Providence Bicycle and Pedestrian Advisory Commission

Staff Report: Proposed restriping of Olney Street – College Hill, Mount Hope - Wards 2 and 3 (For Action)

Presented at July 19, 2017 BPAC meeting

Project Map

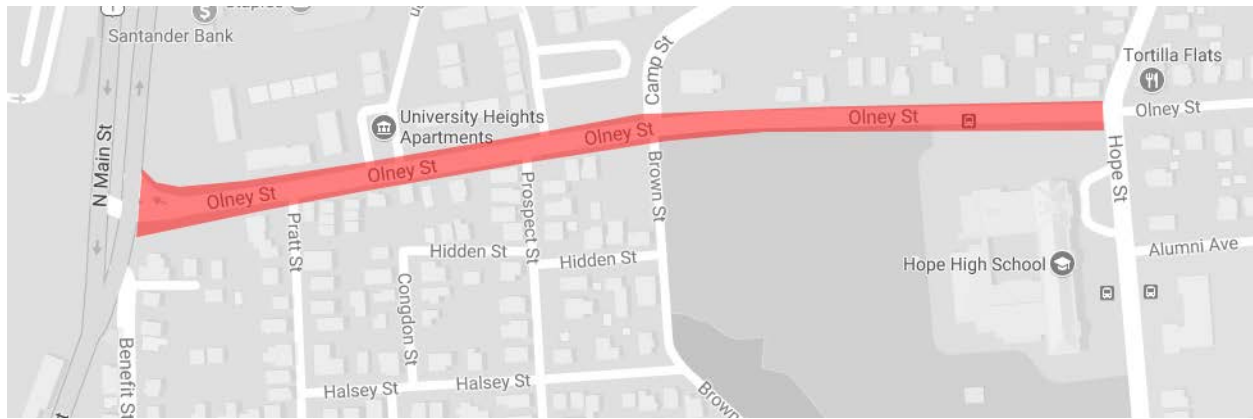
The latest version of the plans includes bike lanes along the entire stretch from North Main Street to Hope Street. In order to fit the bike lanes, 10 out of 10 existing on street parking spaces on Olney Street between North Main and Pratt streets would be removed, and 25 out of 75 existing on street parking spaces on Olney Street between Pratt and Hope streets would be removed.
